CITY OF AUSTIN
APPLICATION TO BOARD OF ADJUSTMENT
INTERPRETATIONS
PART I: APPLICANT'S STATEMENT
(Please type)

STREET ADDRESS: 1917 David Street, Austin Texas 78705

Re: 2011-106377PR

Re: Standing to appeal 1917 David Street , permit 2011-106377PR, 2012-001658 BP

③ ATTIC SECTION 31'6"

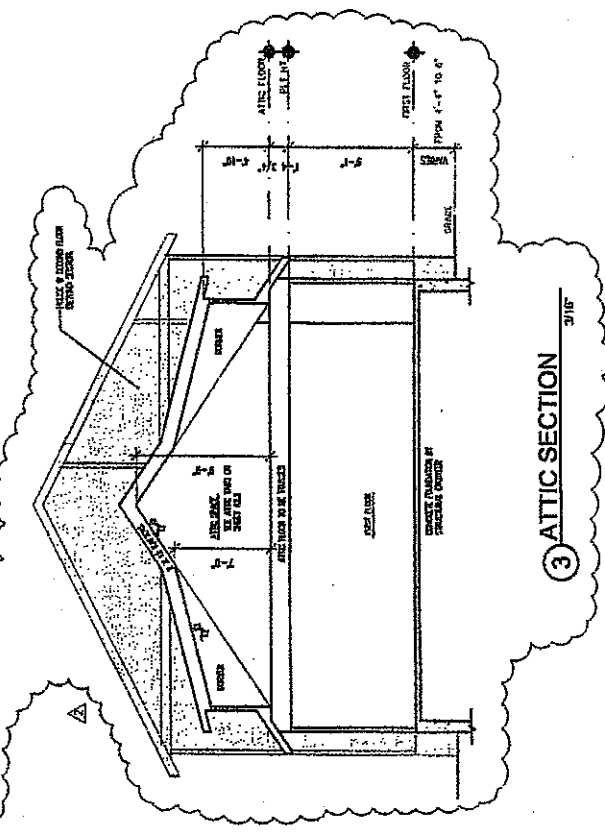
- B) The attic space does not meet the exempt attic requirements outlined on 25-2, Subchapter F, Article 3, 3.3.3. The habitable space adds mass and is not fully contained within the roof structure.

B) The attic space does not meet the exempt attic requirements outlined on 25-2, Subchapter F, Article 3, 3.3.3

The permit at this time states that "each unit has space at the highest floor which is exemptible under 25.2 subchapter F." We reserve the right to appeal this if not addressed by the time of the hearing. More information will be provided, if the exemption remains on the permit.
